UNITED STATES
NUCLEAR REGULATORY COMMISSION
WASHINGTON, D. C. 20555

WPPSS NUCLEAR PROJECT NO. 2

AMENDMENT TO FACILITY OPERATING LICENSE

Amendment No. 54
License No. NPF-21

FIGURE 4.7-1
 SAMPLE PLAN 2) FOR SNUBBER FUNCTIONAL TEST

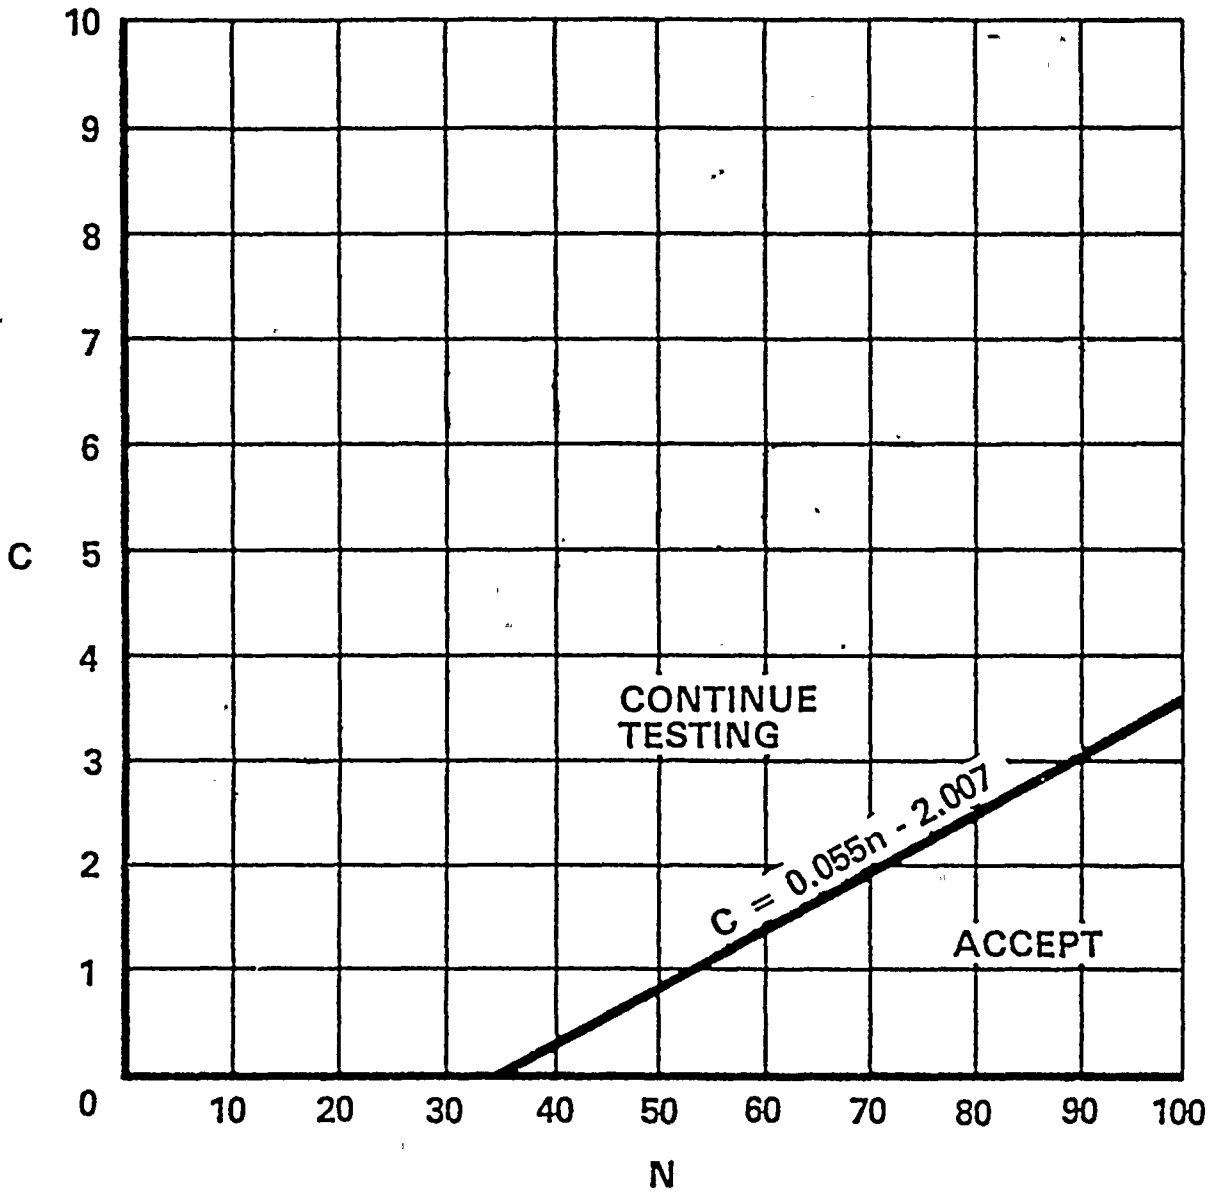
- 2) A representative sample of 37 snubbers shall be functionally tested in accordance with Figure 4.7-1. "C" is the total number of snubbers found not meeting the acceptance requirements of Specification 4.7.4f. The cumulative number of snubbers of a type tested is denoted by "N". If at any time the point plotted falls in the "Accept" region, testing of snubbers may be terminated. When the point plotted lies in the "Continue Testing" region, additional snubbers shall be tested until the point falls in the "Accept" region or all the snubbers have been tested. Testing equipment failure during functional testing may invalidate that day's testing and allow that day's testing to resume anew at a later time provided all snubbers tested with the failed equipment during the day of equipment failure are retested.
